RE: TOWN OF YORKTOWN
Cleaning and Cement Mortar Lining of Water Mains along Underhill Avenue and Front Street

ADDENDUM NO. 2RESPONSES TO QUESTIONS

FRONT STREET - STA. FS 0+00 TO STA. FS 7+46

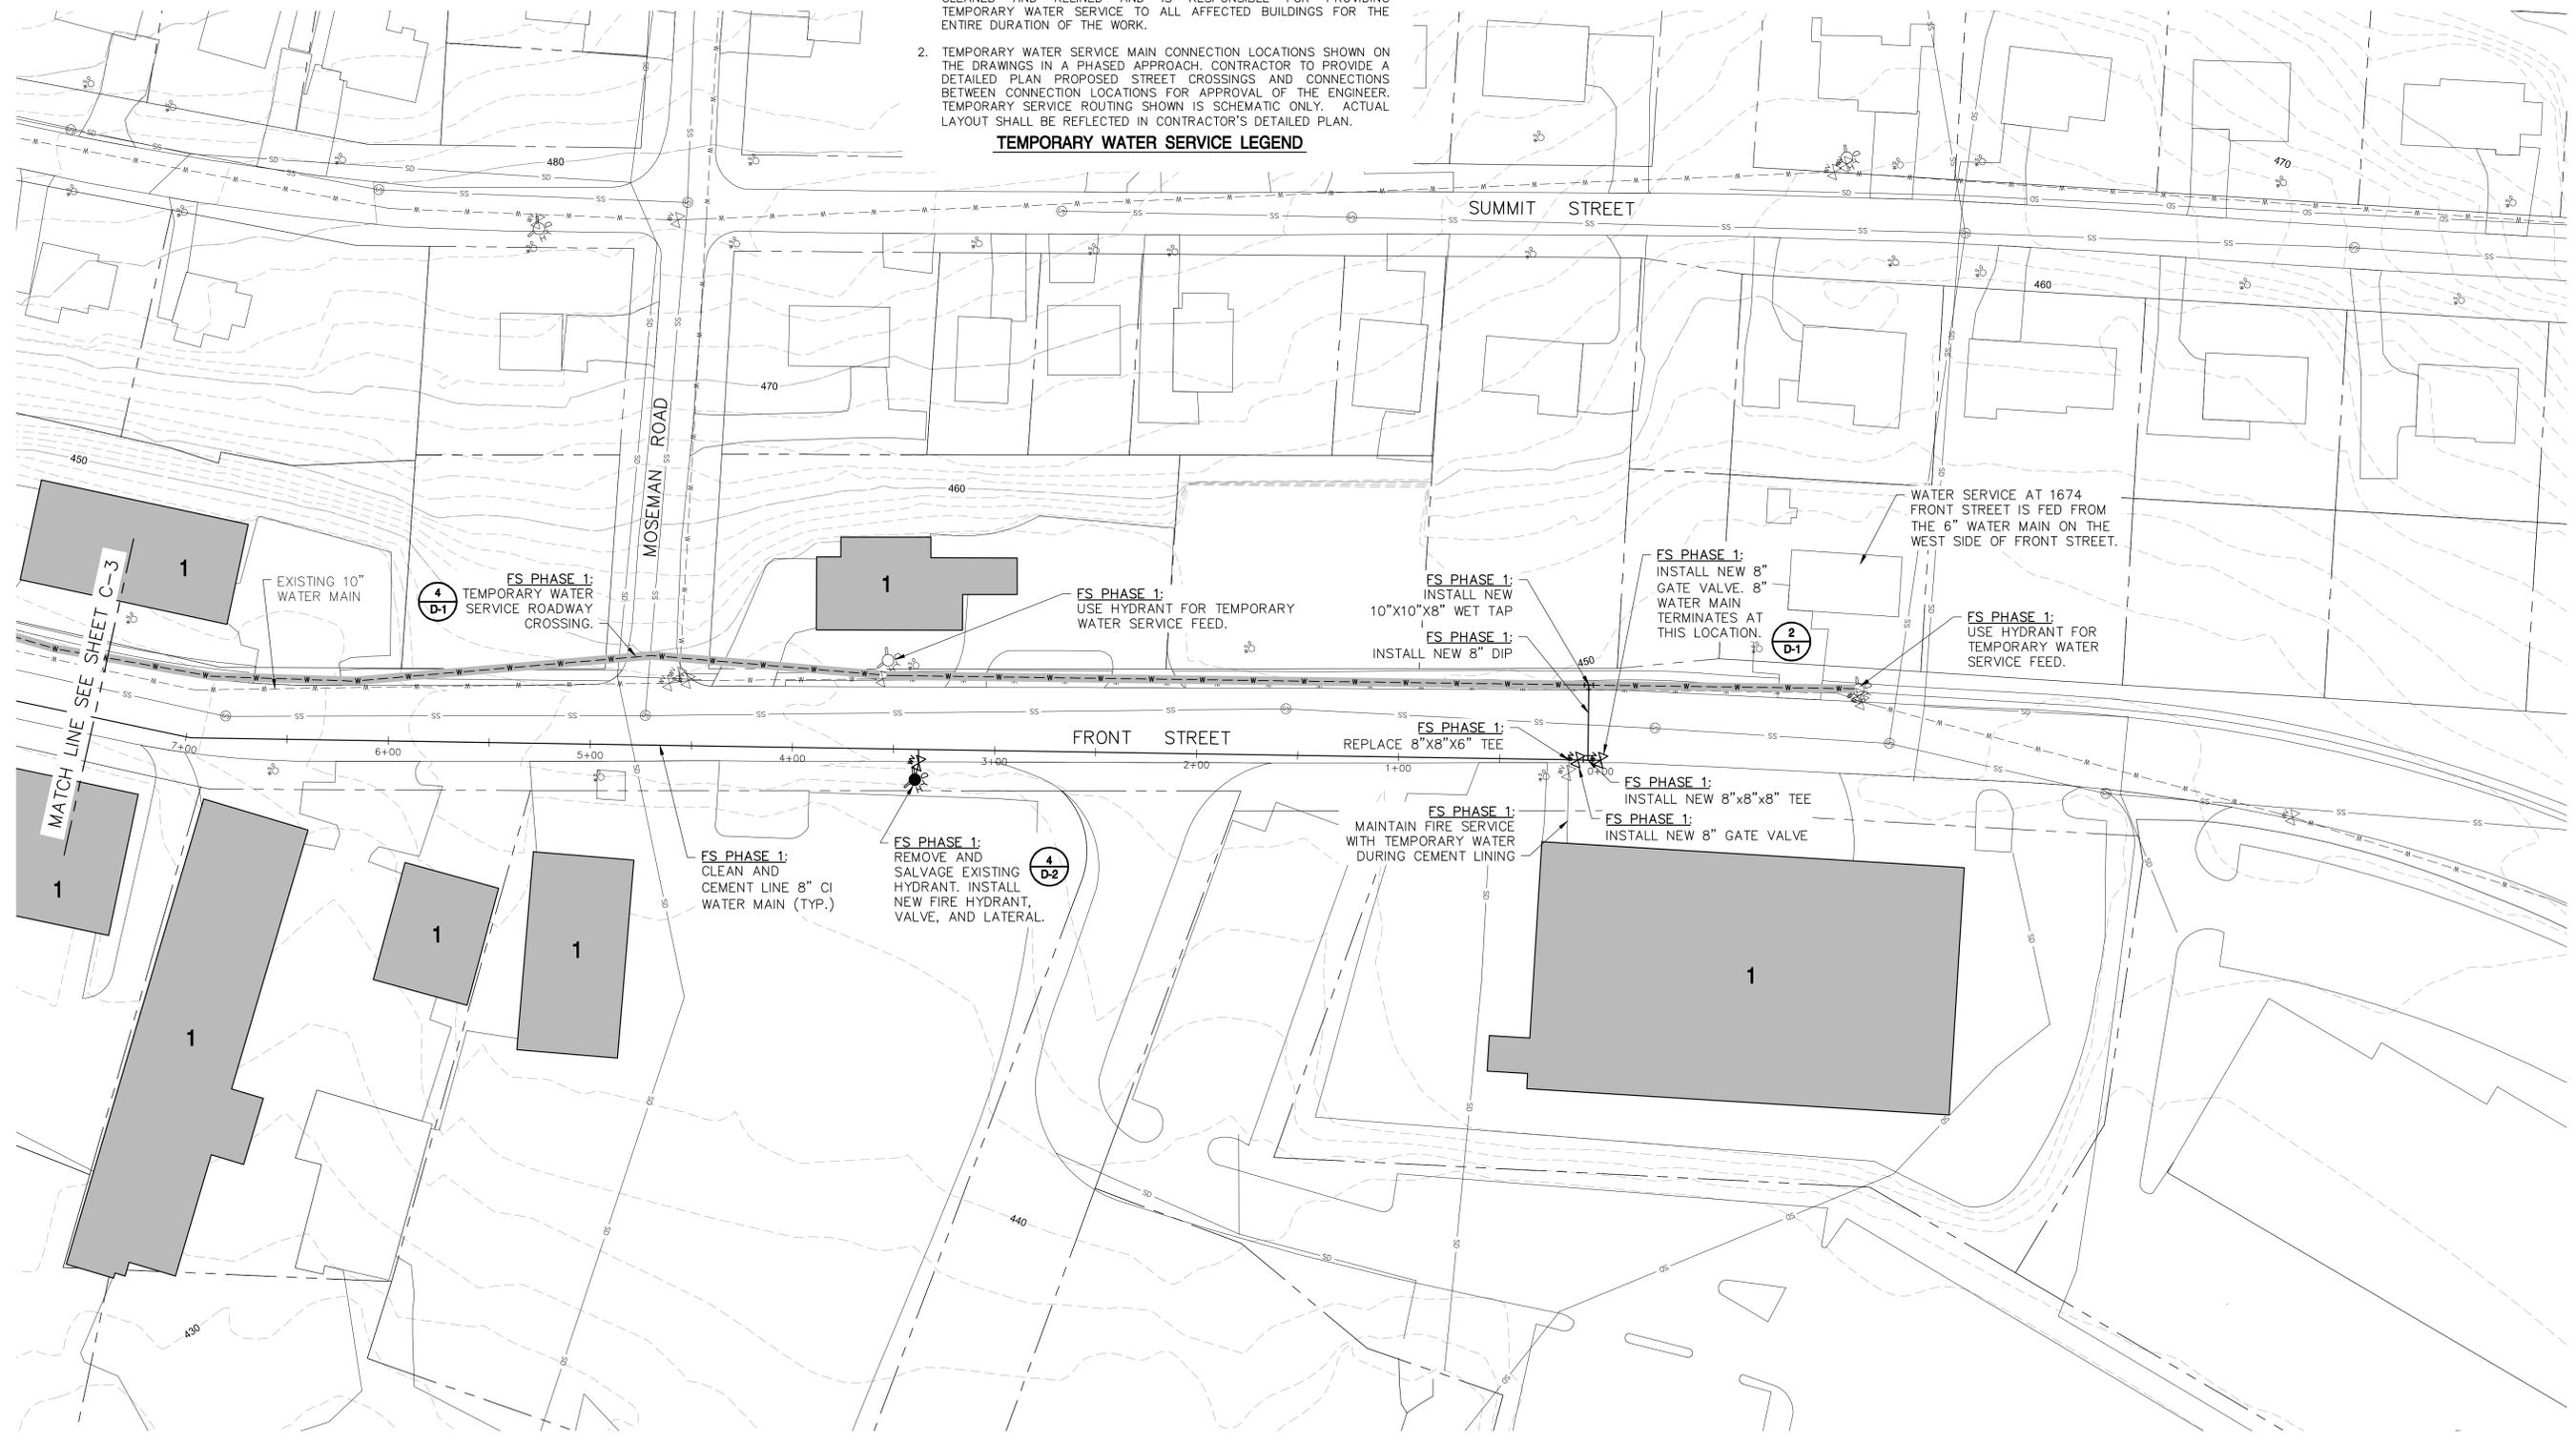
- Sheet C-2: STA 0+14 The fire department connection (FDC) will be connected to the temporary water service feed for 1661 Front Street.
- Sheet C-2: STA 0+25 The water service for 1661 Front Street will be supplied by the temporary water service feed.

- Sheet C-2: STA 1+75 The water service for 1688 Front Street will be supplied by the temporary water service feed.
- Sheet C-2: STA 3+40 The water service for 1700 Front Street will be supplied by the temporary water service feed.

- Sheet C-2: STA 4+95 The water service for 1711 Front Street will be supplied by the temporary water service feed.
- Sheet C-2: STA 6+60 The water service for 1725 Front Street will be supplied by the temporary water service feed.

- Sheet C-2: STA 7+40 The water service for 1736 Front Street will be supplied by the temporary water service feed.
- Sheet C-3: STA 8+08 The water service for 1735 Front Street will be supplied by the temporary water service feed.
